HORTON COASTAL ENGINEERING PTY LTD  
18 Reynolds Cres  
Beacon Hill NSW 2100  
+61 (0)407 012 538  
peter@hortoncoastal.com.au  
www.hortoncoastal.com.au  
ABN 31 612 198 731  
ACN 612 198 731

4 October 2022

**Response to Sydney North Planning Panel on Items Raised in Deferral Letter dated 26 September 2022 in Relation to Newport SLSC (PPSSNH-301 – DA2021/2173)**

**Figure 1: Contiguous piles with plug piles (example from Collaroy-Narrabeen Beach private coastal protection works tender documentation)**

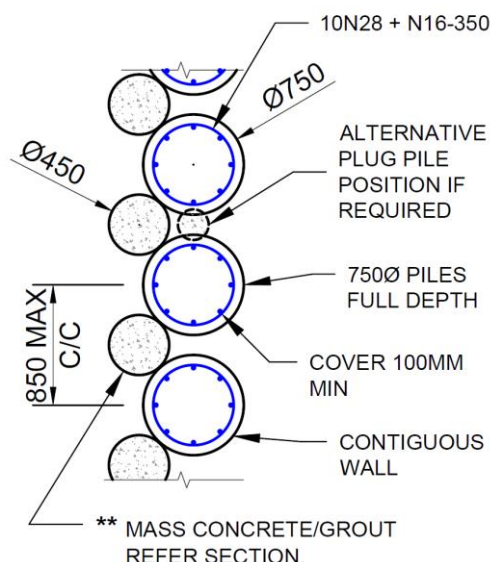
Secant piles are proposed. Contiguous piles with plug piles (see example in Figure 1) achieve a similar continuous barrier to migration of soil and may also be considered if this suits the contractor's methodology, and this methodology satisfies the Principal's structural, coastal and geotechnical engineers. Neither option is necessarily better or worse, and they can both achieve the same outcome of a continuous barrier.
